A Service Bulletin

MOTOR CYCLES LIMITED
GREET, :: BIRMINGHAM, 11, :: ENGLAND.

NUMBER 3/60.

IGNITION - FLYING CADET MODEL L.15A.

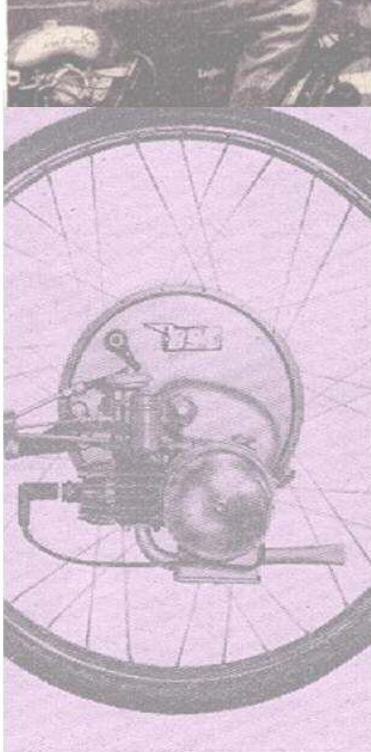
The first batch of stator plates as fitted to this model have caused some trouble due to the method of attaching the H.T. lead to the H.T. coil.

In these original assemblies the H.T. lead had a star washer soldered on the end, the idea being that when the lead was inserted into the coil box aperture to make contact with the terminal inside the washer would hold it in position, but in some cases movement took place resulting in the breaking of the contact.

The resultant gap caused high voltage and subsequent final breakdown.

The manufacturers have introduced a modification incorporating a wood screw in the coil to which the H.T. lead is screwed. (The star washer is no longer fitted). About six turns of the lead will ensure correct assembly, but care must be taken to ensure that the lead is screwed in centrally so that the screw does not pierce the protective covering.
